# WARFIGHTER SUPPORT

## Independent Expert Assessment of Army Body Armor Test Results and Procedures Needed Before Fielding

Highlights of [GAO-10-119](#), a report to congressional requesters

**Figure 4: Graphic Representation of the Difference between the Point of Aim and the Deepest Point**

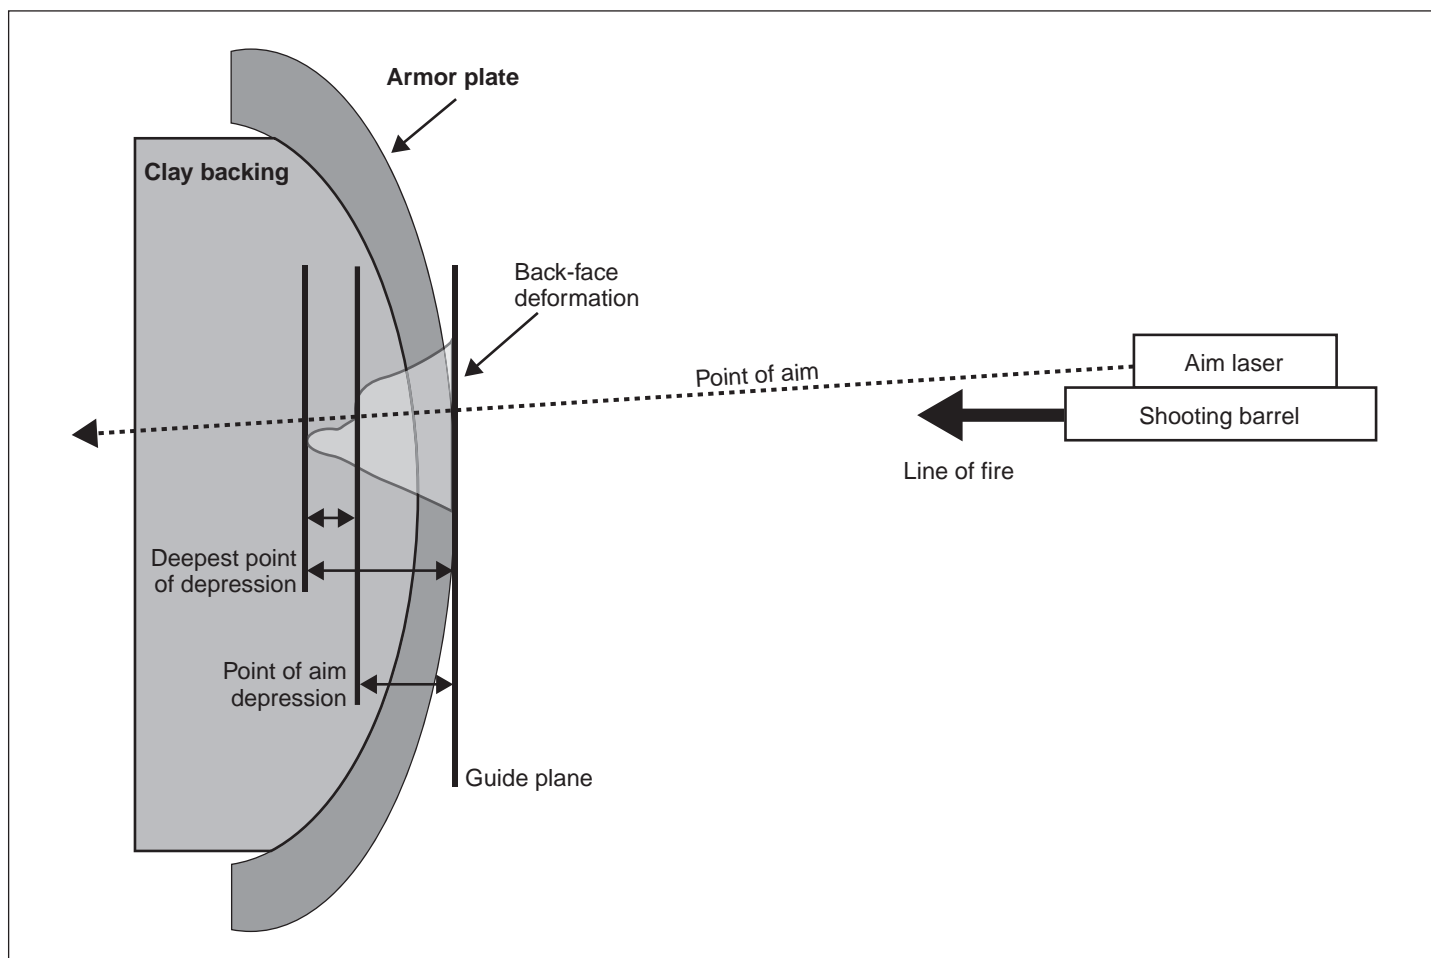
deformation is to be measured at the deepest point of the depression in the clay backing. This measure indicates the most force that the armor will allow to be exerted on an individual struck by a bullet. According to Army officials, the deeper the back-face deformation measured in the clay backing, the higher the risk of internal injury or death. During approximately the first one-third of testing, however, Army testers incorrectly measured deformation at the point of aim, rather than at the deepest point of depression. This is significant because, in many instances, measuring back-face deformation at the point of aim results in measuring at a point upon which less ballistic force is exerted, resulting in lower back-face deformation measurements and overestimating the effectiveness of the armor. The Army's subject matter experts on the Integrated Product Team were not on the test lanes during testing and thus not made aware of the error until approximately one-third of the testing had been completed.

When members of the Integrated Product Team overseeing the testing were made aware of this error, the Integrated Product Team decided to begin measuring at the deepest point of depression. When senior Army leadership was made aware of this error, testing was halted for 2 weeks while Army leadership considered the situation. Army leadership developed many courses of action, including restarting the entire Preliminary Design Model testing with new armor plate submissions, but ultimately decided to continue measuring and scoring officially at the point of aim, since this would not disadvantage any vendors. The Army then changed the test plans and modified the contract solicitation to call for measuring at the point of aim. The Army also decided to collect deepest point of depression measurements for all shots from that point forward, but only as a government reference. During the second two-thirds of testing, we observed significant differences between the measurements taken at the point of aim and those taken at the deepest point, as much as a 10-millimeter difference between measurements. As a result, at least two of the eight designs that passed Preliminary Design Model testing and were awarded contracts would have failed if the deepest point of depression measurement had been used. Figures 4 and 5 illustrate the difference between the point of aim and the deepest point.

**Figure 6: Tears in Kevlar Backing Material after a Penetration of the Plate**

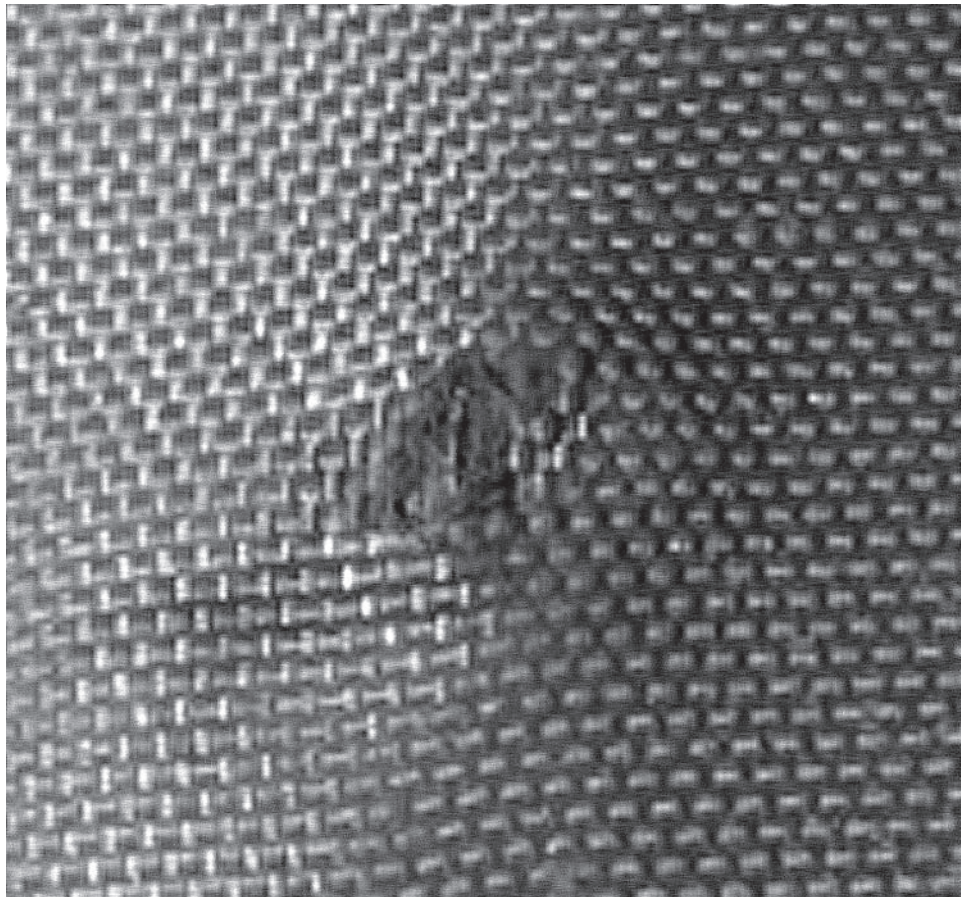
DOD also did not agree with our finding that a penetration of a plate was improperly scored. DOD did agree that figure 6, which shows the tear in the Kevlar fibers of the rear of the plate in question, appears to show evidence of a perforation and that an Aberdeen Test Center ballistics subject matter expert found particles in the soft backing material behind the plate. Nevertheless, DOD did not concur with our finding because it asserted that no threads were broken on the first layer of Kevlar. However,

In addition to the DOD acknowledgement that an Aberdeen Test Center subject matter expert found particles on the soft body armor, more convincing evidence is the picture of the subject plate. Figure 6 of our report clearly shows the tear in the fibers that were placed behind the plate in question allowing the penetration of the particles found by the Aberdeen Test Center subject matter expert. These particles can only be fragments of the projectile or fragments of the armor material that passed into the soft under garment used behind the protective inserts (plates), confirming our observations of the event and the subsequent incorrect scoring. The shot should have been scored a complete penetration, and the penalty incurred would have caused the design in question to fail First Article Testing.

Figure 3. BFD Measurement Reference Guide from Purchase Description.

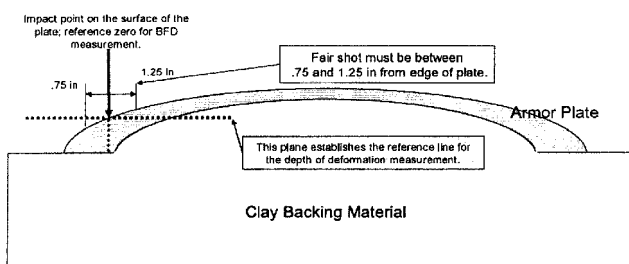
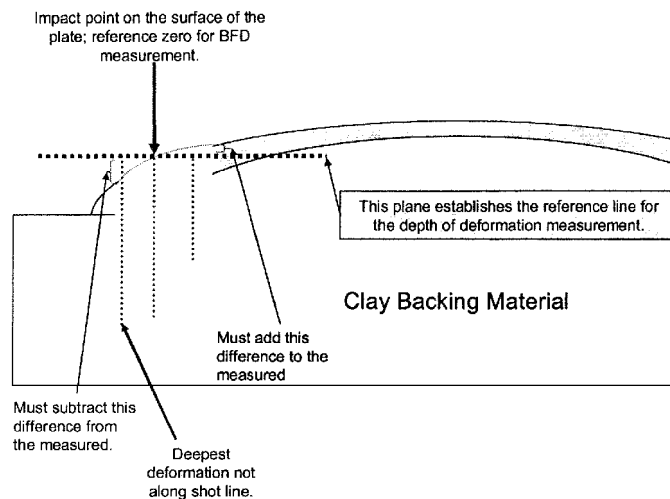
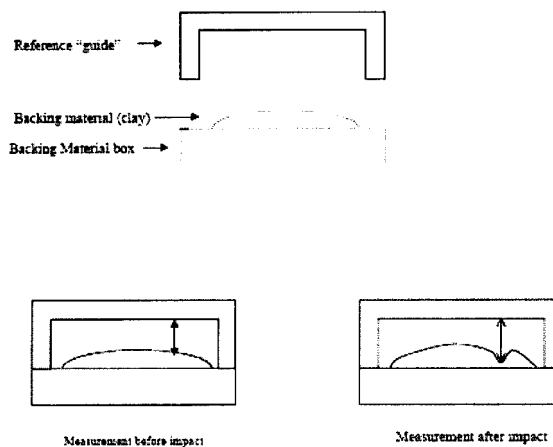
**Assertion 5** – Army tester's incorrectly measured the amount of force absorbed by the designs tested by measuring back-face deformation at the point of aim rather than at the deepest point of depression. (Page 5 of 48, paragraph 1; and, Page 21-23 of 48.)

**Response:** Though ATC deviated from the test protocol in the Purchase Description regarding measuring BFD at the lowest deformation, Army leadership after a deliberative internal process and in consultation with DOT&E, decided to use the BFD point-of-aim measurement as it was determined to be an accurate and repeatable process that did not bias any vendor's design. The following information highlights the rationale for this decision. For clarity and reference, Figures 1 and 2 depict the geometry associated with this issue. Further discussion follows the figures.

Referencing the first sentence of the above quote, the only known reference point prior to a test shot is the aim point (“original undisturbed surface of the backing material”). Prior to the shot, the test technician has no way of knowing the surface location perpendicular to the lowest point of depression. The fixed reference guide identified in the quote, shown in Figure 3, can only assist in establishing the aim point as

There are two important considerations pertaining to the guidance in the Purchase Description: First, the lowest point of depression must be subjectively selected by a test technician, and second, measuring perpendicular from the point selected as the lowest point of depression to the reference guide provides the distance between that point and the original undisturbed surface at the aim point, not the original undisturbed surface perpendicular to the lowest point of depression, which is what is required to obtain an accurate measurement. Using the technique described, an accurate measurement can only be made if the measurement is made on a flat surface with a uniform original undisturbed reference surface. However, since the plates are curved and the radius varies between vendor plates and even within vendors for same plate sizes, as shown in Figure 4, the only point at which an accurate measurement can be made with the described measuring device is the aim point.

Figure 5. Results of ATC analysis of test results for all vendor designs against the most formidable threat.

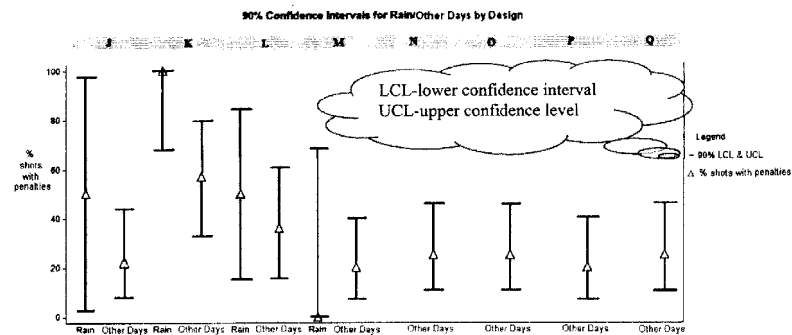
**Response:** Non-concur. The GAO asserts that its statistical analyses indicate that exposure of the clay used to test a vendor on November 13, 2008, to “constant heavy, cold rain” caused unusual test results on that day. The DoD does not concur with that assessment. Based on the GAO assertion, the Army Test and Evaluation Command (ATEC) conducted its own statistical analyses on the test results for all designs tested on November 13, 2008.

ATC analysis also shows that the poor performance of the vendor's design in question was attributed to its marginal performance against the most formidable threat round under test, not to a brief time (seconds) of exposure to a “constant heavy, cold rain and low temperatures” or the effects of rain on the clay surface. Statistical analyses were performed on the test results for all designs including those tested on November 13, 2008. The result of that analysis, as shown in Figure 5, indicate Design K was the weakest

design on days with no rain as well as days with rain. Design K had a 70 percent failure rate during all testing against the most formidable threat. Even when excluding the rain day data, which was when that design was subjected to the most stressing tests, the design still had a 57 percent failure rate.

Figure 6. Front face of shoot pack for the test in question.

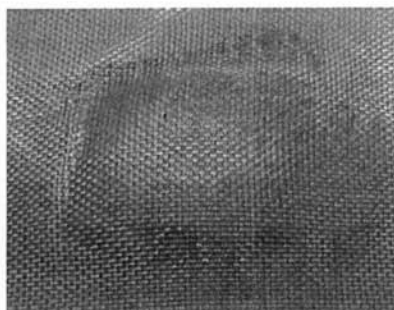
**Assertion 8 -** During First Article Testing Army testers improperly scored a complete penetration as a partial penetration. (Page 8 of 48, paragraph 1; and, Page 32 of 48, paragraph 2.)

**Response:** This information appends that provided in the earlier discussion of this issue. While Figure 6 of the GAO report appears to show evidence of a perforation on the rear of the test plate in question, by the definition in the Purchase Description, a complete perforation is scored based upon the damage to the soft armor shoot pack directly behind the ballistic test plate. The front (face immediately behind the plate under test) of the shoot pack in question is shown in Figure 6 of this response, located below. Though deformed, the damage does not constitute a complete perforation of the plate according to the definition in the Purchase Description.
